Subject: Duke Power Company LLC d.b.a.
Duke Energy Carolinas, LLC
McGuire Nuclear Station, Unit 1
Docket No. 50-369

Emergency License Amendment Request for One-Time Limited
Duration Extension of Allowed Outage Time for the Unit 1A
Emergency Diesel, Request for Additional Information

Response to Request for Additional Information

Figure 2

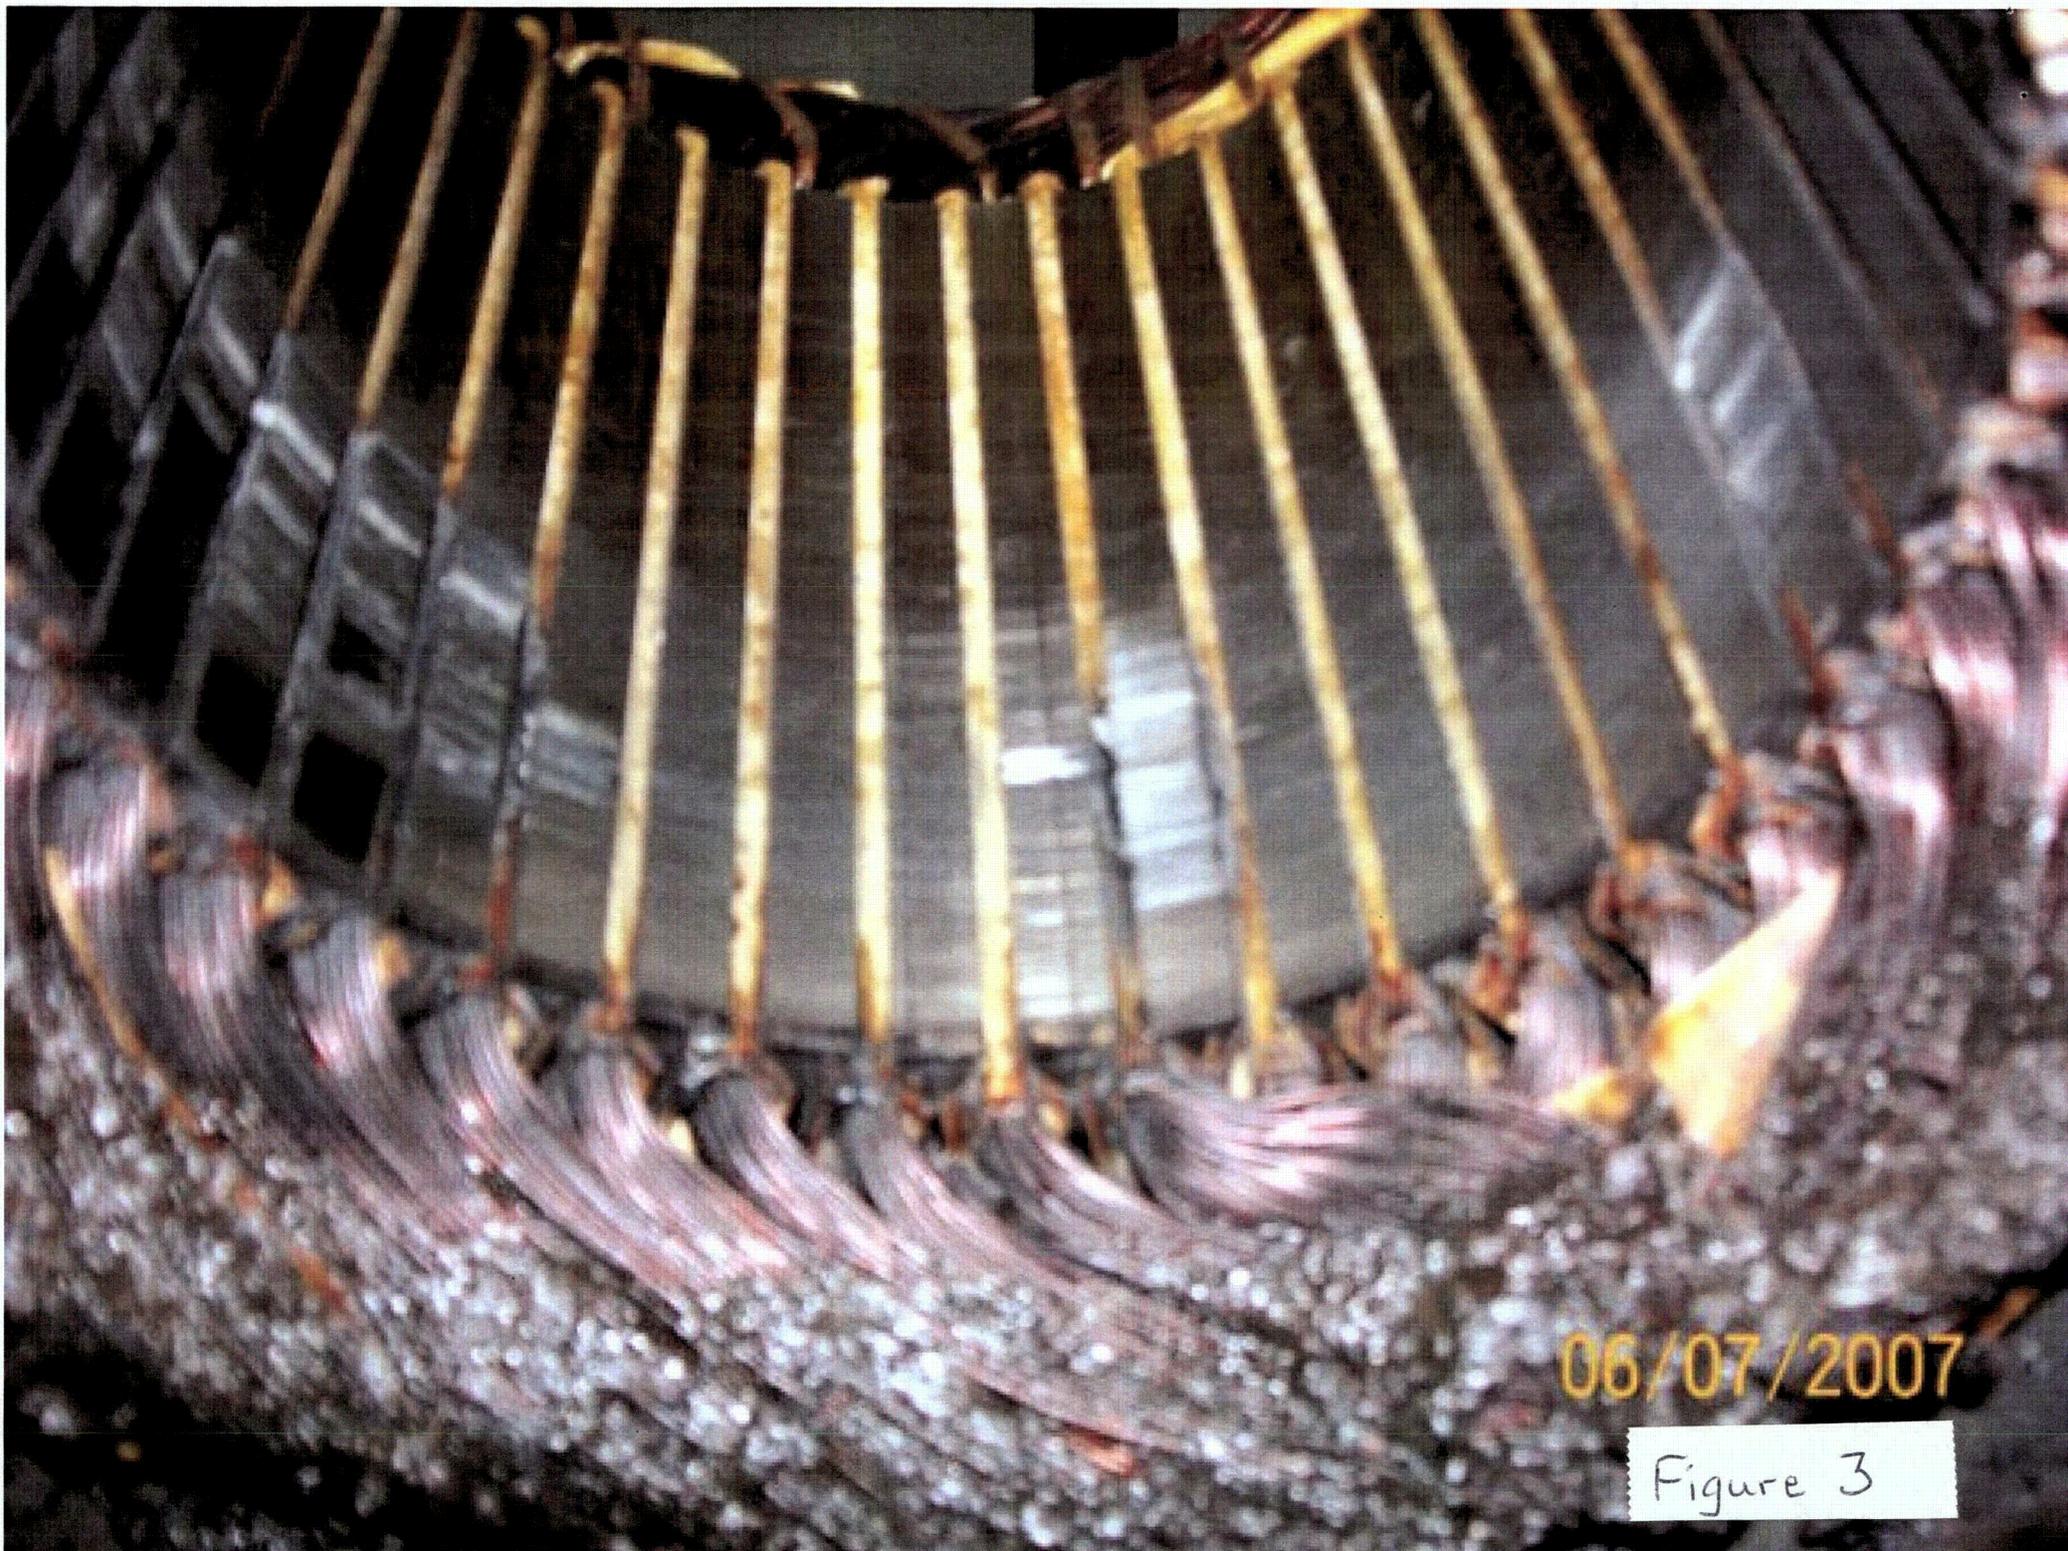
Additional information is requested regarding the McGuire 1A Emergency Diesel Generator (EDG) jacket water and intercooler pump motor overload alarm of June 6, 2007, motor testing and inspections, and the results of Duke's investigations.

The vendor disassembled the motor and provided photographs of an apparent hard rub between the stator and rotor (Figure 1, 2, and 3). There were also numerous pieces of metal particles inside the end-bell and in the end turn windings of the stator (Figure 2, 3, and 4). Since an apparent rub was in several places around the circumference of the stator winding, the initial cause investigation (based on vendor supplied photos only) suggested a bearing failure. However, this was later refuted as discussed below.

Again, based on pictures provided by Shultz Electric earlier on 6/7/07 of the disassembled motor, there appeared to be an indication of a hard rub between the rotor and the stator. However, the apparent rub was actually aluminum that flowed out of the rotor due to heat, that smeared onto the stator. Given that the bearings did not indicate degraded condition, this supports the conclusion that the rotor did not come into contact with the stator.

The pictures, specifically of the bracket, show loose aluminum particles. Any aluminum imbedded in the windings or the slot can provide a tracking path to ground, resulting in degraded indications from the DC HI-POT test and surge test performed at McGuire prior to shipping the motor to the repair facility. The degraded core due to the melted aluminum would lead to higher current draw, causing the overload alarm that was received, and would be expected for this condition.
